SAFETY ADVISORY # 14-219

Laredo Mini Breaker Relocation

Models Included: 2015 Laredo Travel Trailers

Fig. 2

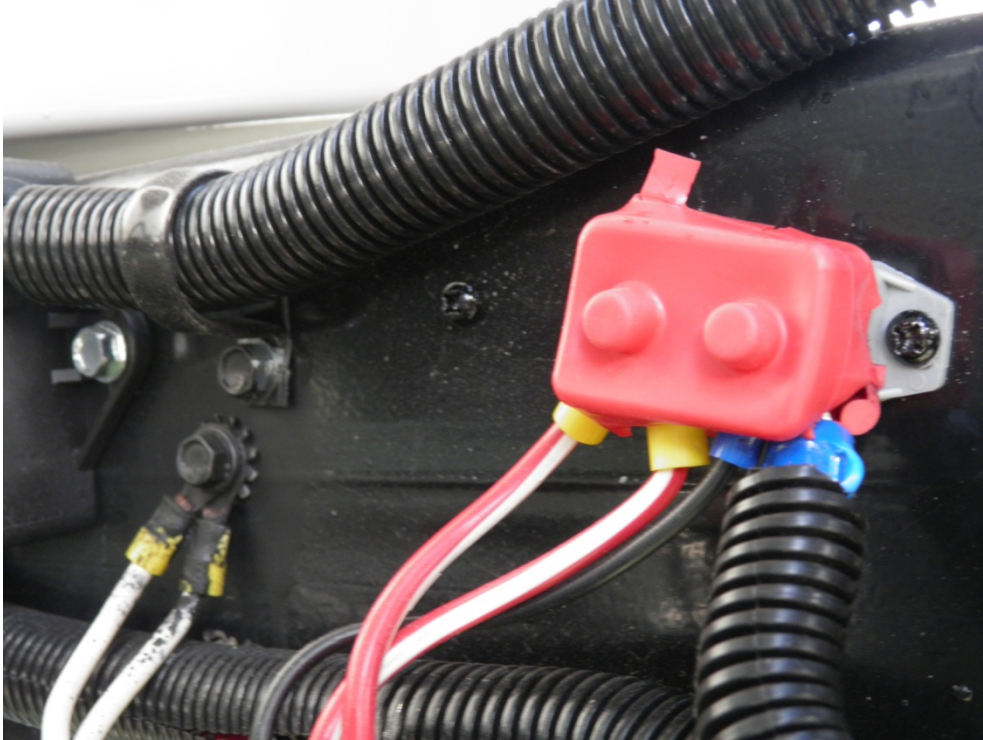
Remove the two screws holding the rear mini breaker to the A frame. Reposition the mini breaker forward so the rear mounting hole of the mini breaker is now aligned with the front screw hole and secure to the frame. Add a screw to the front mounting hole of the mini breaker and to the hole which is no longer being used. See figure 2.
